Appendix S:
Response to Submissions
Public

Public Comment Summary

CANBERRA LINE INDUSTRIAL SIDINGS FYSHWICK

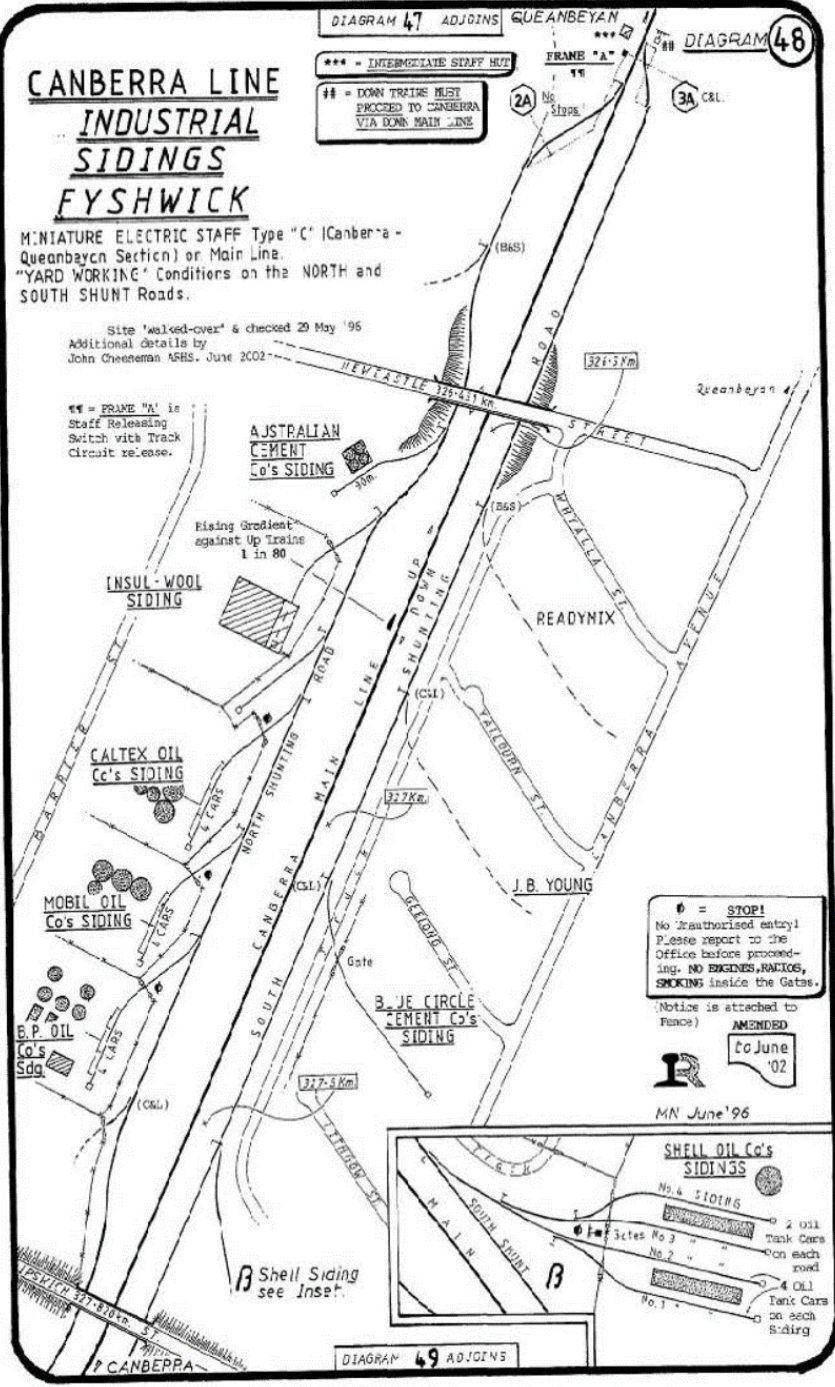
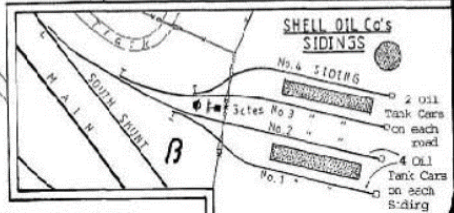
16.10	Rail siding is not enough justification to cause impacts – not planned well	The site previously had direct rail access. The environmental risks have been quantified and mitigated if necessary, so it is an appropriate location and the Territory Plan permits the activities proposed. With population of Canberra expected to double in the next 40 years the only option is to use more trucks to service the city. As there is a perfectly good, albeit underutilized, rail network in existence the increased use of this would seem to be sensible initiative, especially at this stage of the city’s growth.	No action required
